RE: US Eagle FCU – Juan Tabo
1955 Juan Tabo NE
Grading and Drainage Plan Stamp Date: 11/21/19
Hydrology File: H21D029

Based on the submittal received on 2/7/20, the Grading and Drainage Plan cannot be approved until the following are corrected:

RE: US Eagle FCU – Juan Tabo
1955 Juan Tabo NE
Grading and Drainage Plan Stamp Date: 11/21/19
Hydrology File: H21D029

Attached is the revised Grading, Drainage, and Utility Plans and Details for the proposed US Eagle FCU development on Juan Tabo. The following addresses the comments received on December 20, 2019 regarding the plans submitted on December 16, 2019:

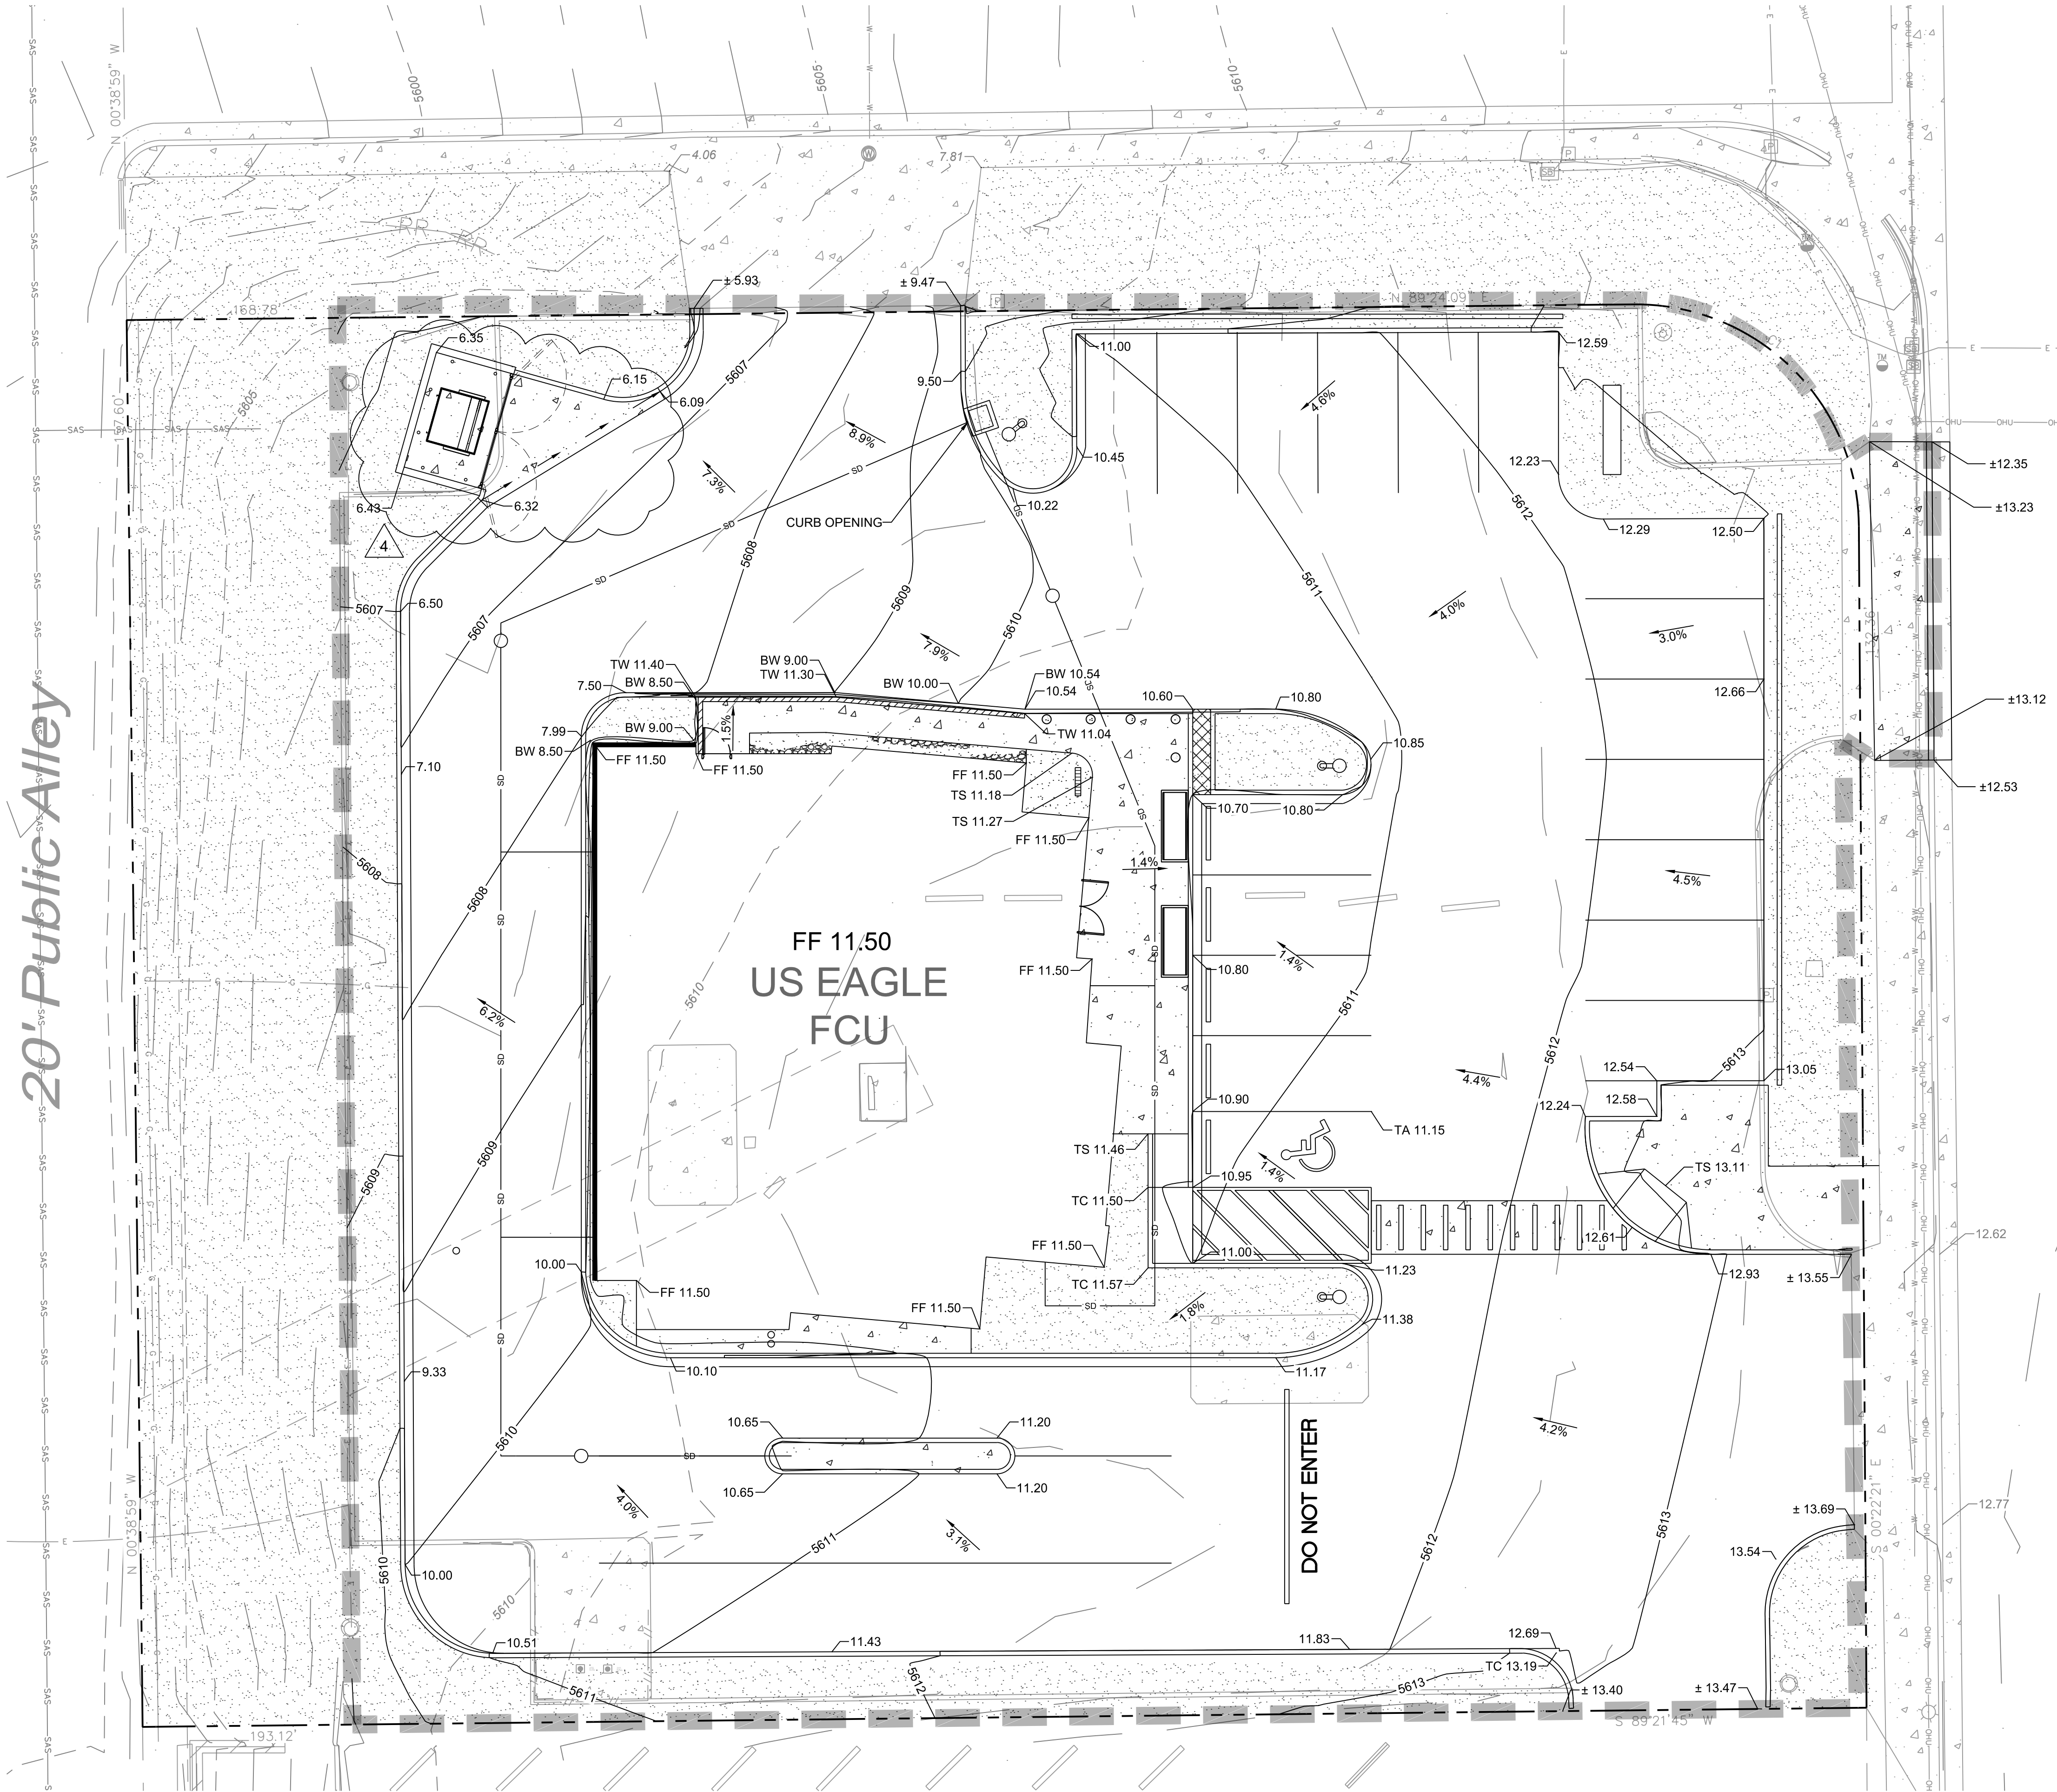
4. Provide slope stabilization for the sloped area between the alley and parking lot.
5. As a reminder, if the project total area of disturbance (including the staging area and any work within the adjacent Right-of-Way) is 1 acre or more, then an Erosion and Sediment Control (ESC) Plan and Owner's certified Notice of Intent (NOI) is required to be submitted to the Stormwater Quality Engineer (Doug Hughes, PE, jhughes@cabq.gov, 924-3420) 14 days prior to any earth disturbance.

- / A waterblock, 0.87' high, per COA Paving Detail No. 2426, is required at the driveway entrance (Juan Tabo side).**

- / Show the grading and paving for rebuilding the alley.**

A water block is provided higher than 0.87' high. See revised sheet C-102.

No paving nor grading is proposed for the alley. The documents in the City Hydrology folder for a previous development for this site (attached) state that improvements to the alley are not required for the following reasons: (1) the alley is not needed for access, (2) it is not needed for the discharge of developed runoff from the site, (3) it is not apparent that the developed commercial properties along Juan Tabo are using the alley for access, (4) it does not appear that future access to the alley will be needed, and (5) the vertical alignment of the existing alley has a constant grade of approximately 1% from south to north. The proposed conditions for the site are consistent with the prior development, which was not required to improve the alley.
